Subject: Comments on Incorporation by Reference of American Society of Mechanical Engineers Codes and Code Cases, 10 CFR Part 50, RIN 3150-AK22, Docket ID NRC-2018-0290

ASME Comments on 10 CFR 50.55a Proposed Rule, Federal Register, Vol. 86, No. 57, pp. 16087-16114, Friday, March 26, 2021, RIN 3150-AK22, Docket ID NRC-2018-0290

ASME Section XI Working Group on Operating Plant Criteria Comments to proposed Section XI condition: “Prohibitions and Restrictions on use of IWB-3510.4(b), IWC-3510.5(b), Table A-4200-1, and Table G-2110-1”

Figure 1, K_{Ic} vs $T - RT_{NDT}$ for ASTM A-533 Type B Class 2 [Hawthorne, 1972]

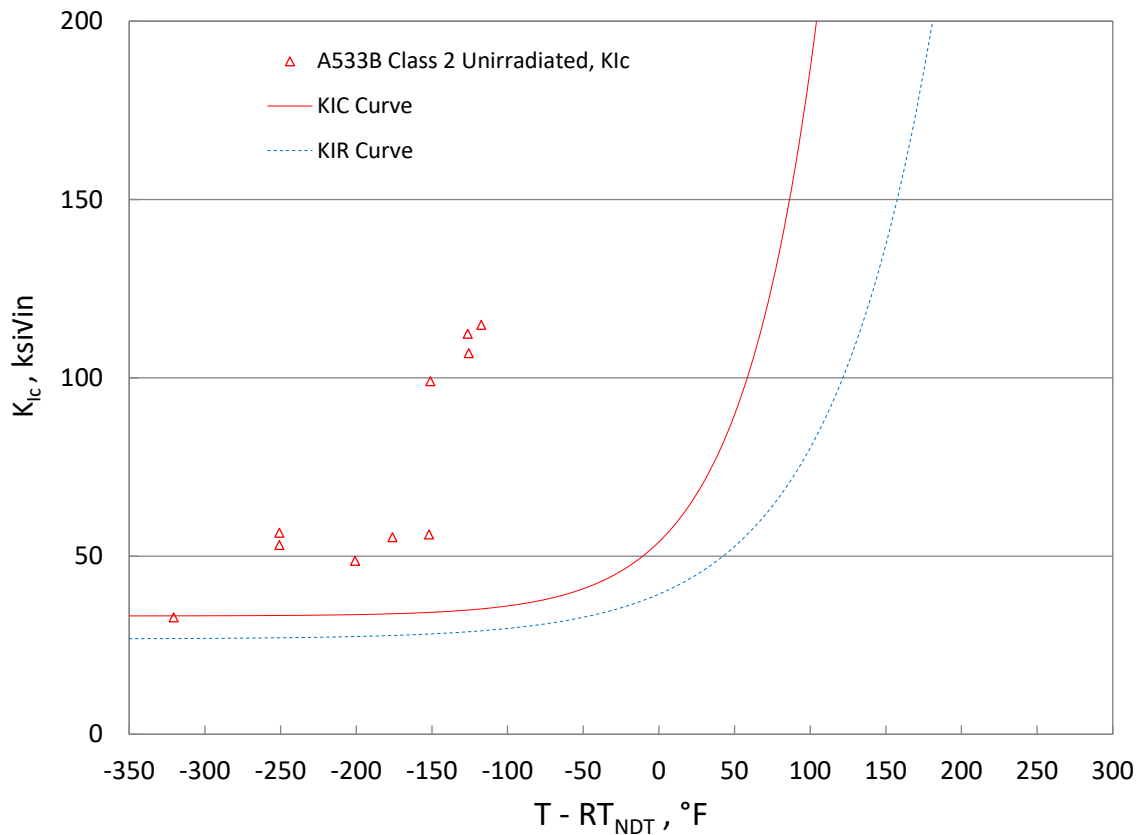
Figure 1 plots the unirradiated K_{Ic} data assuming RT-NDT = 0°F. The unirradiated T-NDT was 0°F; RT-NDT was not reported because RT-NDT was first adopted by Section III, NB-2300 in 1973. Judging from the unirradiated Charpy curve, the unirradiated RT-NDT per NB-2300 definition may be higher than T-

NDT. If RT-NDT were higher than 0°F, the plotted K_{Ic} test data in Figure 1 would shift toward the left, resulting in higher margin against the minimum K_{Ic} curve than shown in Figure 1. Therefore, the K_{Ic} test data exceeded the minimum K_{Ic} curve in Figure G-2210-1 and Figure A-4200-1.

Figure 2, K_{Ic} and K_{Id} vs $T - RT_{NDT}$ for SQV2B [Hayashi, 2004]

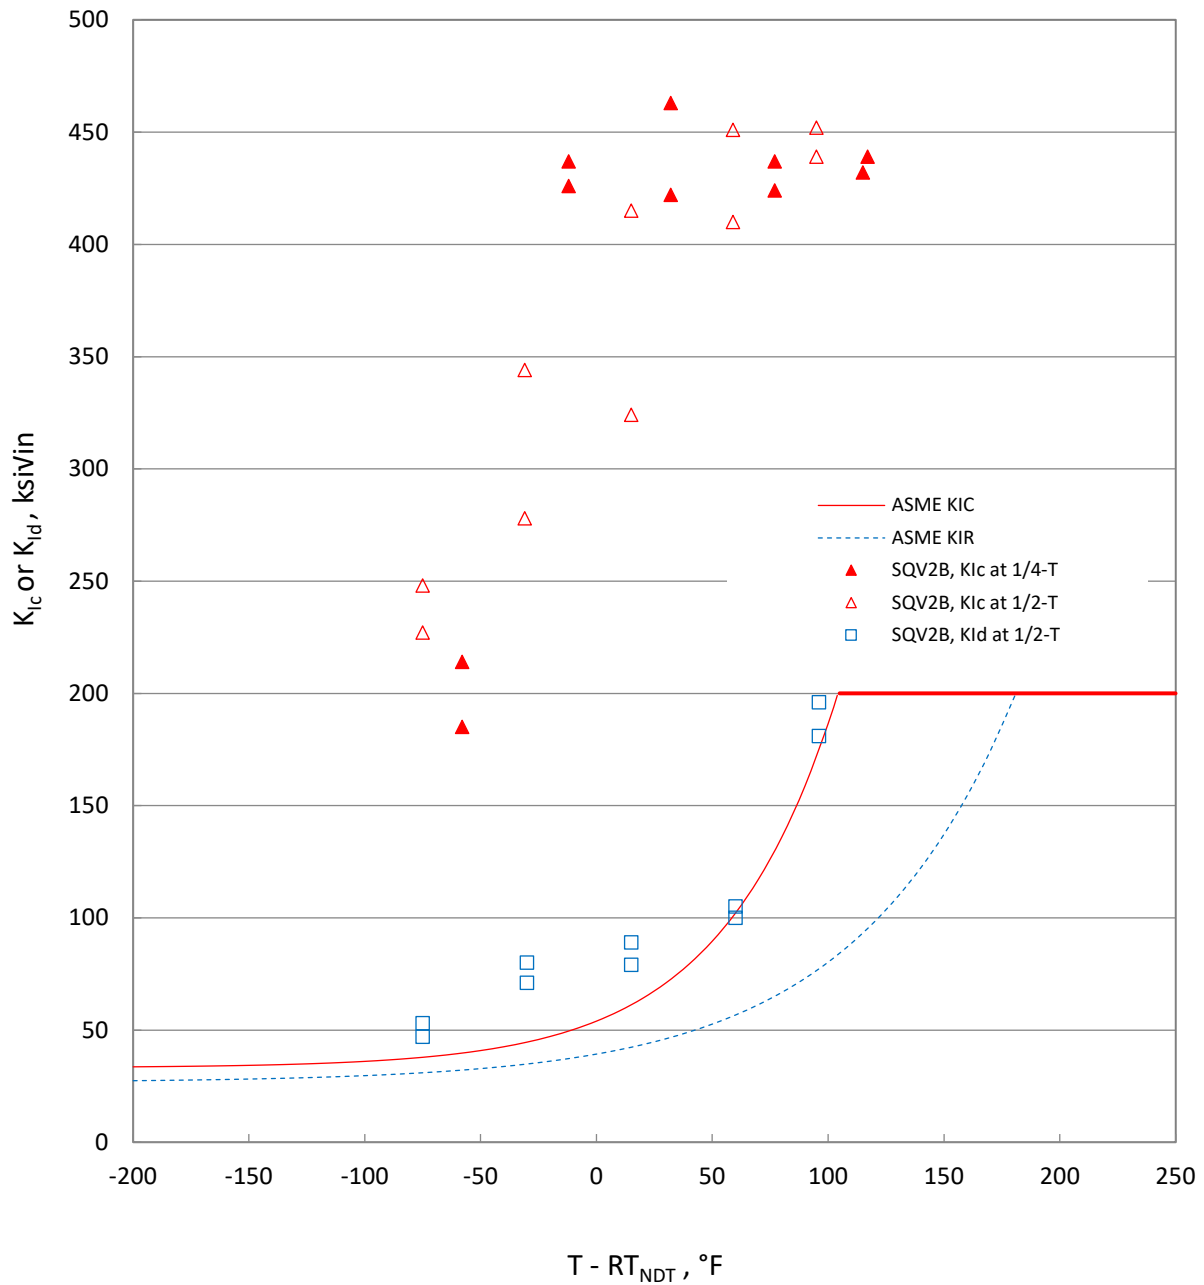
Figure 2 plots the K_{Ic} and K_{Id} test data. The RT-NDT was -33°C (-27°F). Figure 2 shows that the K_{Ic} test data exceeded the minimum K_{Ic} curve in Figure G-2210-1 and Figure A-4200-1. The K_{Ic} test data were significantly above the K_{Id} test data, and even the K_{Id} test data met the minimum K_{Ic} curve.

The above test data for SA-533 Type B Class 2 were not included in PVP2019-93988; they provide additional support to the PVP2019-93988 conclusion that the four grades of ferritic steels can be considered as one group for the applicability of the minimum K_{Ic} curve in Section XI Appendix A and Appendix G. In light of the additional test data, the proposed condition (restriction or prohibition) on SA-533 Type B Class 2 is unnecessary.
